# DRAFT DECISION Evoenergy Distribution Determination

# 2019 to 2024

# Attachment 5 Capital expenditure

This attachment forms part of the AER's draft decision on the distribution determination that will apply to Evoenergy for the 2019–2024 regulatory control period. It should be read with all other parts of the draft decision.

### Figure 5.2 – Evoenergy historical and forecast augex (\$2018-19)

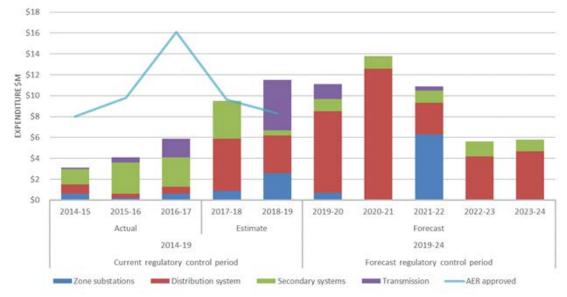
Figure 5.2 indicates that Evoenergy has forecast an increase in augex in the 2019-24 regulatory control period. Evoenergy forecasts an average annual augex increase from

## Figure 5.3 – Evoenergy's zone substation utilisation 2013-14 and 2017-18 actual, and 2023-24 forecast

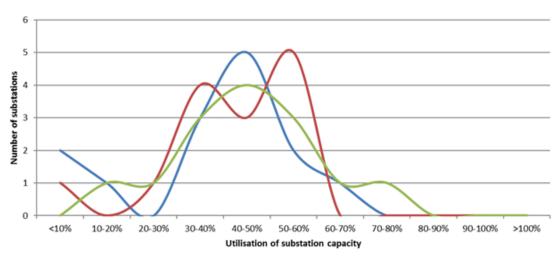
Figure 5.3 shows Evoenergy's zone substation utilisation between 2013-14 and 2017-18, and forecast utilisation in 2023-24 (at the end of the regulatory control period). Between 2013-14 and 2017-18, there has not been a significant shift in the utilisation profile, more substations are operating between 50 to 60 per cent of capacity, but fewer at 60 to 70 percent. The forecast indicates that utilisation rates of some zone substations are likely to increase, but not to levels that would necessitate augmentation.

# Figure 5.7 – Evoenergy's actual repex vs forecast repex (\$2018-19, million, excluding overheads)

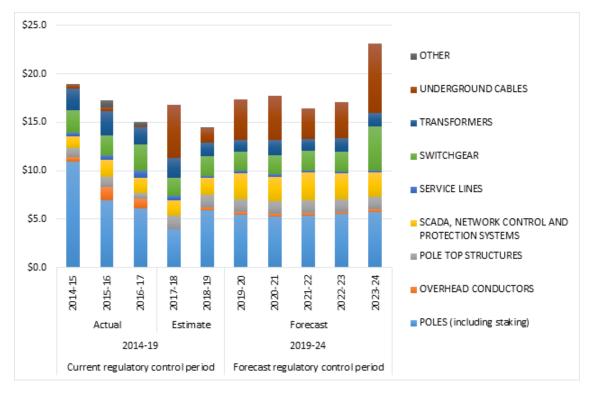
Figure 5.7 indicates that Evoenergy has forecast a slight increase in repex in the 2019-24 regulatory control period. Average annual repex is forecast to increase from \$16.5 million per annum in the 2014-19 regulatory control period to \$18.3 million in the 2019-24 regulatory control period. A forecast step up in 2023-24 is primarily driving this trend. We have applied repex modelling and considered other material submitted by Evoenergy to assess this increase.

# Figure 5.8 – Evoenergy's repex model scenarios (\$2018-19, million, excluding overheads)

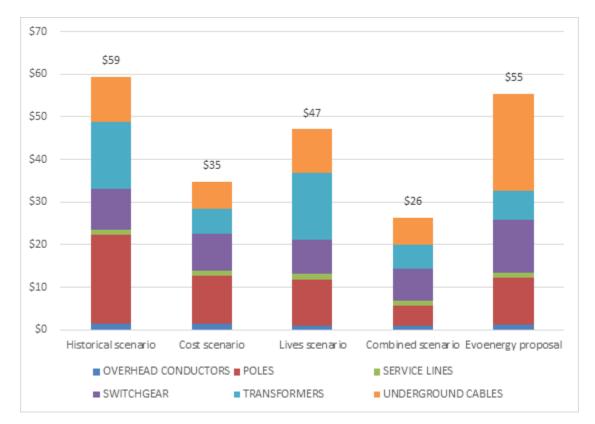
Figure 5.8 reveals that Evoenergy's repex forecast for poles, overhead conductors, service lines and transformers is broadly in line with our repex modelling scenarios, while its forecast for switchgear slightly exceeds our scenarios. However, lower forecasts in other asset groups (primarily transformers) are offsetting this discrepancy in the switchgear asset group.

Figure 5.8 also reveals that Evoenergy's forecast repex proposal differs most significantly from our repex modelling scenarios in the underground cable asset group. Evoenergy's repex forecast for underground cables (\$22.6 million) is 120 per cent higher than our repex model threshold for that asset group (\$10.3 million).

Therefore, our position in this draft decision is that Evoenergy's forecast of \$55.3 million (\$2018-19, excluding overheads) for modelled repex does not form part of a total capex forecast that we are satisfied reasonably reflects the capex criteria. We have included an amount of \$47.1 million (\$2018-19, excluding overheads) in our substitute estimate of modelled repex and total capex. We derive this reduction of \$8.2 million (9 per cent) by reducing Evoenergy's forecast modelled repex threshold to our repex model threshold (Figure 5.8). Our substitute estimate of total repex (\$83.6 million) is slightly higher (\$0.2 million) due to subsequent modelling adjustments.

Figure 5.13 – Evoenergy non-network capex by category (\$2018-19, million)

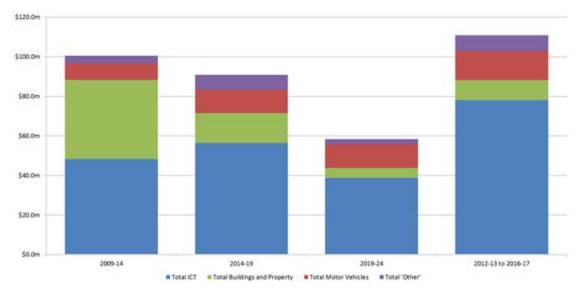
Evoenergy has submitted that its forecast of \$2.5 million for 'other' non-network capex reflects the cost of items of less than \$1,000 and was based on historical expenditure.<sup>127</sup> As shown in Figure 5.13, Evoenergy's forecast is lower than historical expenditure for this category of non-network capex. On this basis, we are satisfied that

## Figure 5.17 – Evoenergy's total actual/estimated and forecast motor vehicle capex (\$2018-19, million)

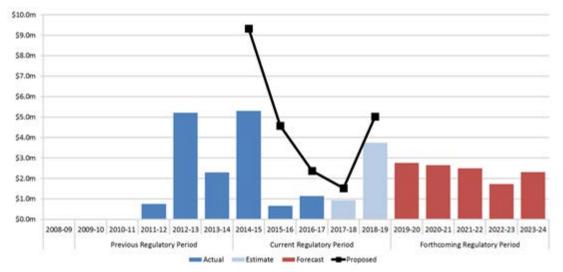
Evoenergy has submitted that the underspend on motor vehicle capex relative to allowance as shown in Figure 5.17 reflected reductions<sup>147</sup> in staff numbers during 2014-15, while also reflecting a preference for extended leases as opposed to replacements.<sup>148</sup> Evoenergy has submitted that it has based its forecast for the forthcoming regulatory period on like-for-like replacement of the current vehicles.<sup>149</sup> We note that Evoenergy has forecast motor vehicle opex and fleet numbers to remain constant over the forthcoming period.
